CONSTRUCTION OF
PAVED
SIDEWALK/ DRIVEWAY

Driveway Review Form

293 Princeton St (NS-113-126)

MAP 113 LOT 129

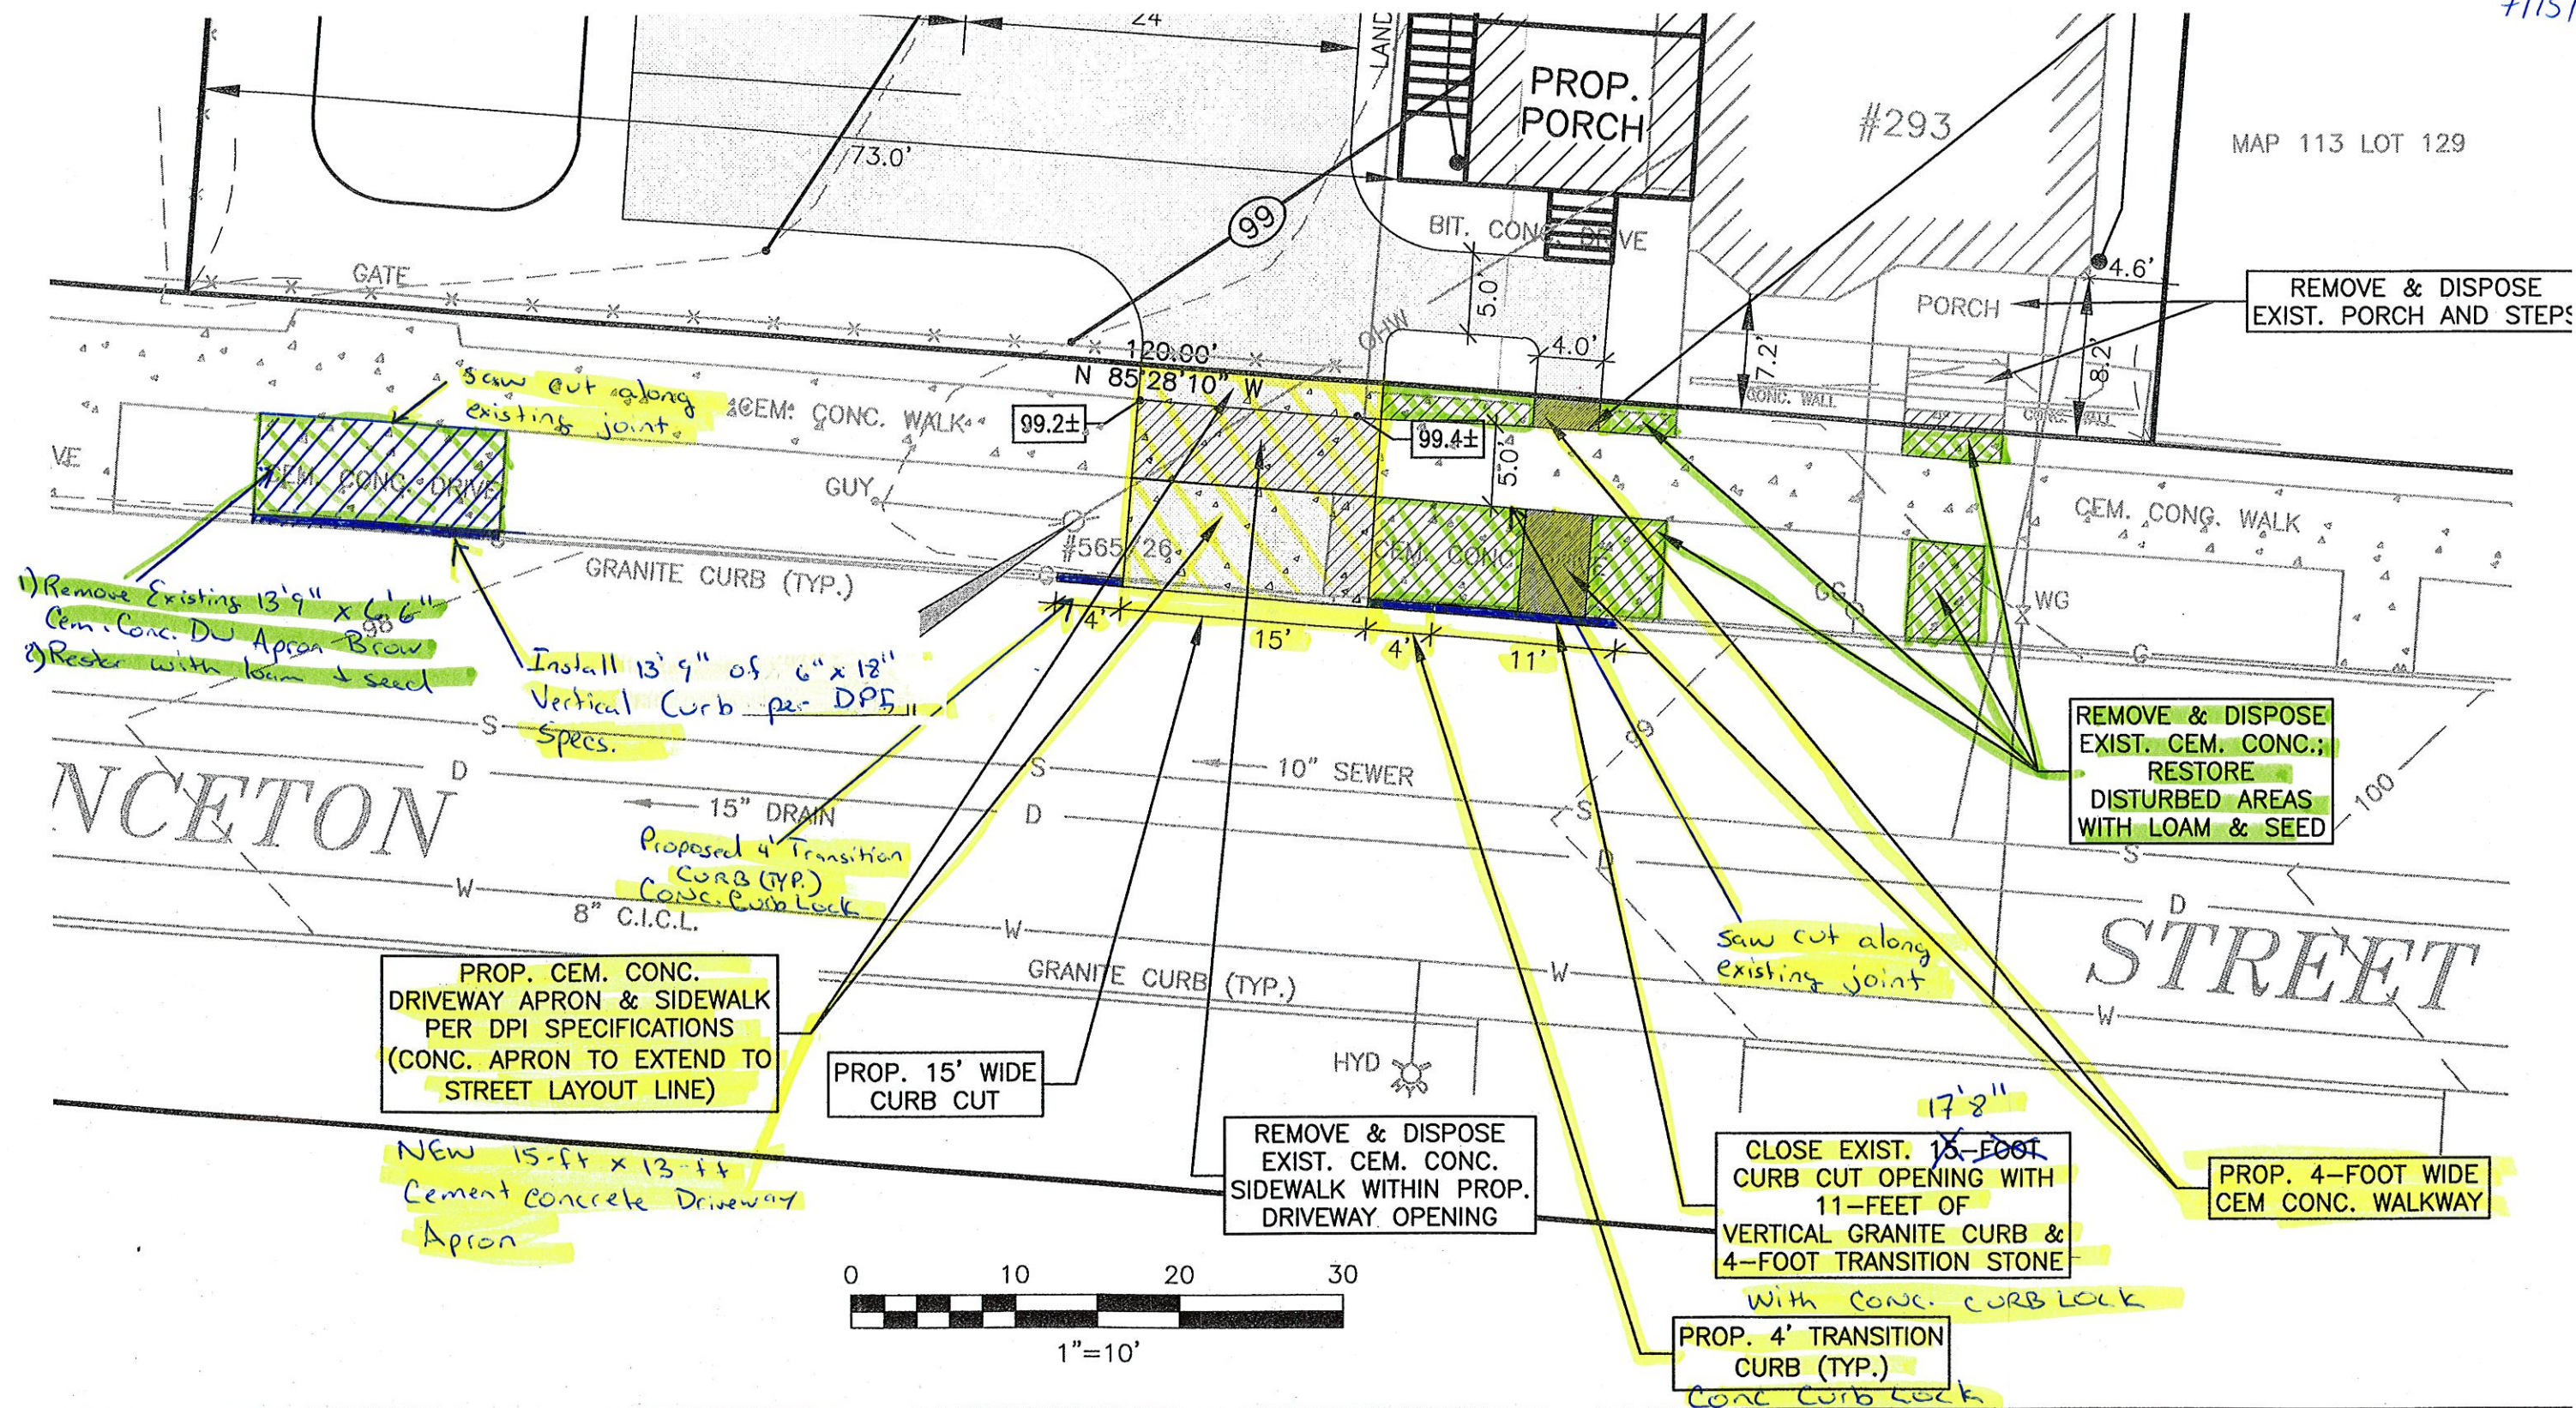
Comments: Requires removing curbing, also existing driveway, create new driveway. See attached

Granite Curb: Will need to supply 17-ft of granite curb for driveway closures.

*Must have all reset curb inspected prior to backfilling.

**Requires approximately 17-ft of new granite curb for driveway closure and transition installation.

1. Remove and reset 11-ft of granite curb per approved plan (attached) and DPI mark-out.
2. Remove existing 17-ft 8-in x 13-ft cement concrete driveway apron on the east side of the property.
3. Remove existing 13-ft 9-in x 6-ft-6" cement concrete driveway apron brow from the existing driveway apron at the west side of the property (see sketch). Saw cut along longitudinal expansion joint between sidewalk and brow, then excavate the brow portion of the driveway apron.
4. Remove the existing sidewalk and grass ribbon from the location of the new driveway.

5. Install new 15-ft x 13-ft cement concrete driveway apron in accordance with the most current revision of the City of New Bedford DPI Construction Standards and Specifications with 4-ft granite curb transitions.
6. Install new cement concrete walkway in line with the steps and grass ribbon as shown on approved plans.
7. Install granite curb to close in driveway on west side of property.
8. Restore all other excavated areas within City layout with loam and seed. Applicant is responsible for establishing grass ribbons including watering as needed.
